S E R V I C E**N O T E**

Supersedes:
E8803A-01A

E8803A PNA Series RF Network Analyzers

July 26, 2007

Figure 1

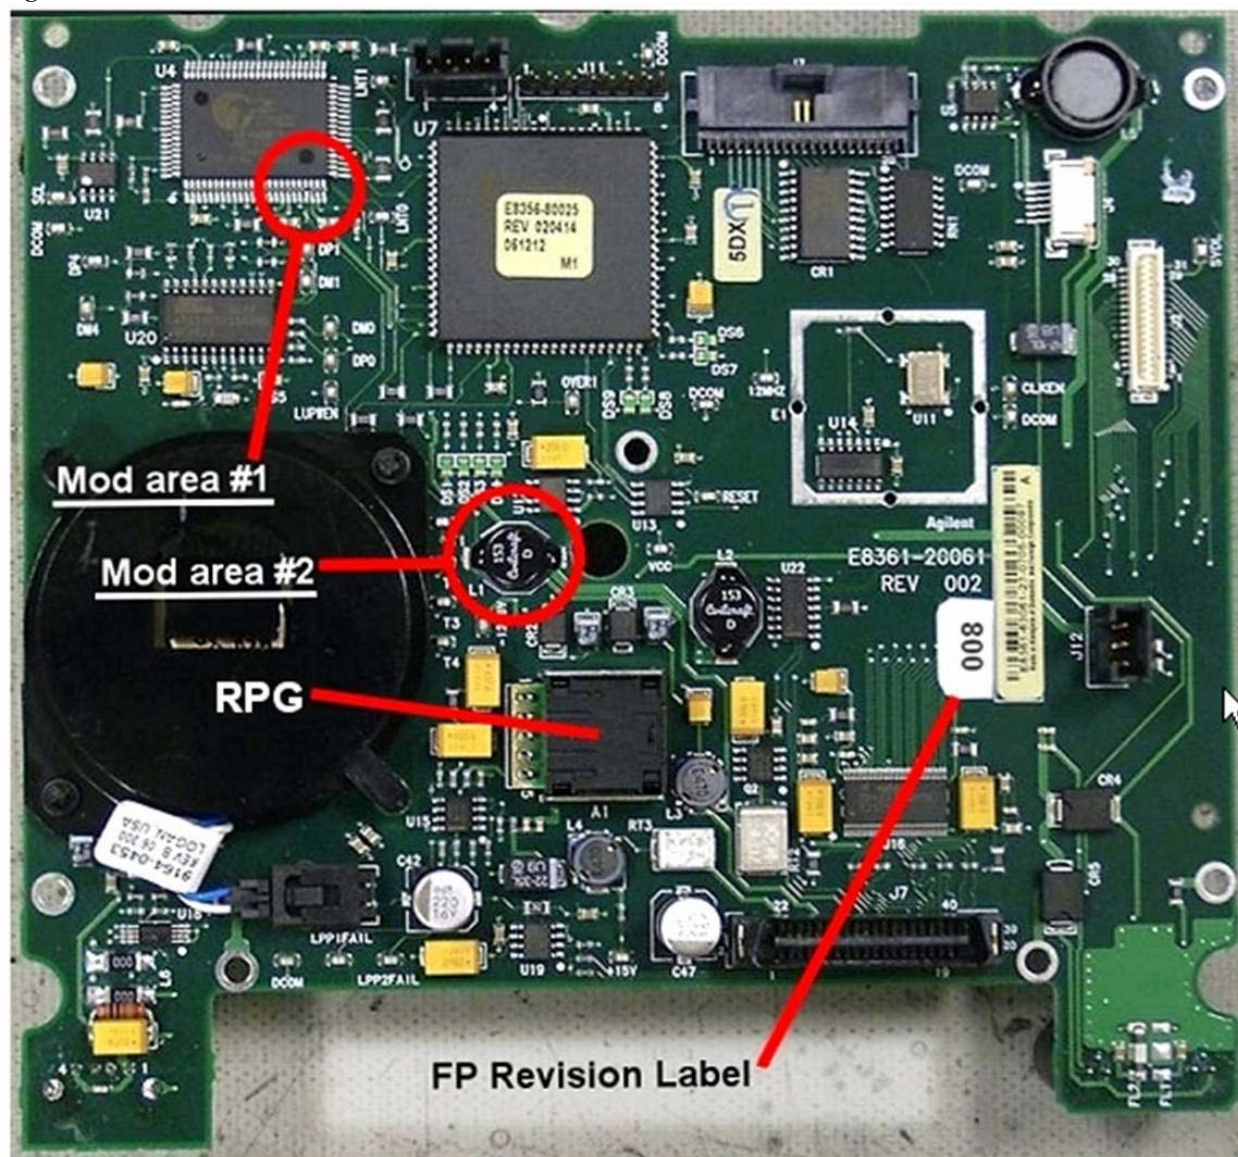
Refer to Figure 1 for the two modification areas to be addressed. Note that while this picture happens to show the FPI board completely removed from the front frame assembly, this is not necessary to perform the required modifications.

- Modification #1 consists of shorting two pins of U4 together with a small amount of solder.
- Modification #2 consist of removing L1.

Unsolder and completely remove the black surface mount inductor L1 from the front panel assembly board. This is no longer needed and can be discarded.

Figure 2

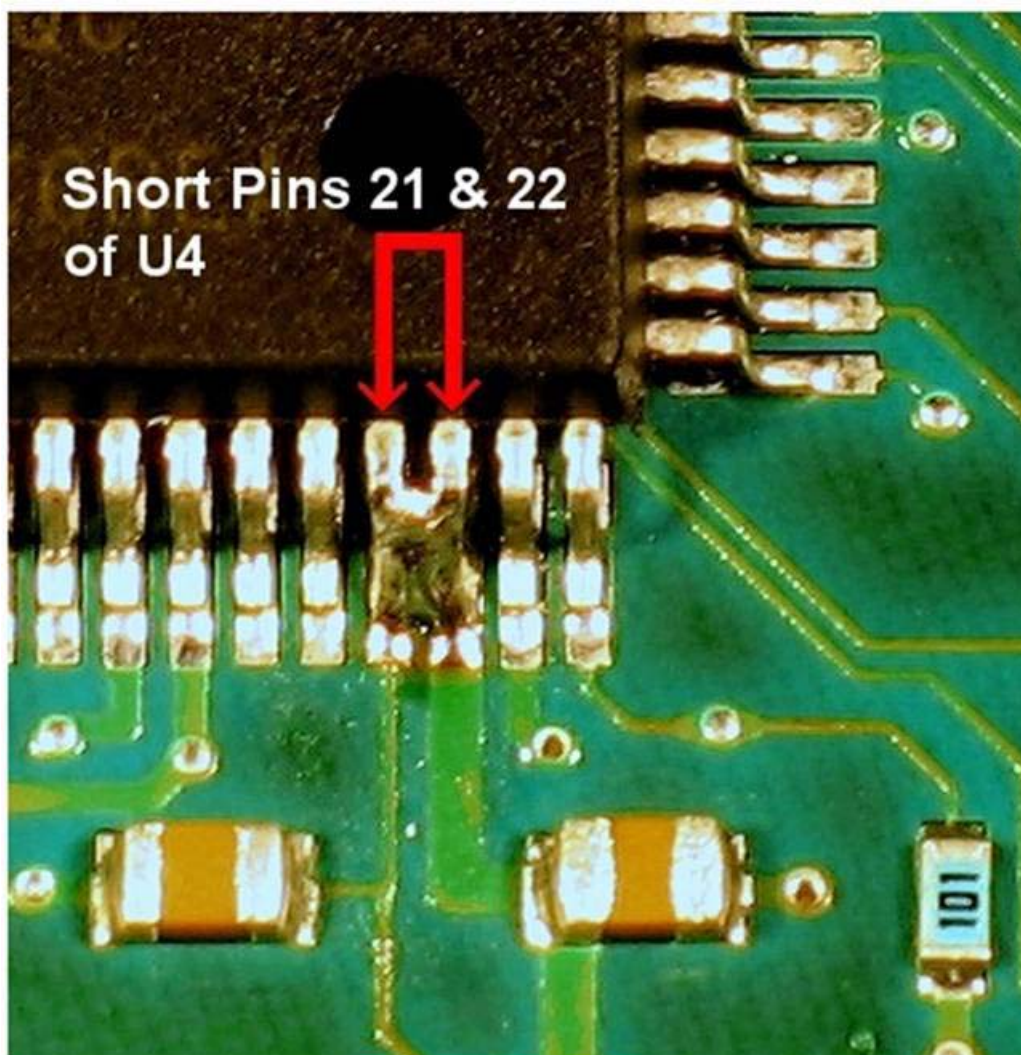
Carefully solder pins 21 and 22 together on U4. Refer to Figure 2 for the exact location. Use care so that no other pins are shorted. Use of a very fine tip soldering iron is recommended and a large work-task magnifying glass is very helpful.
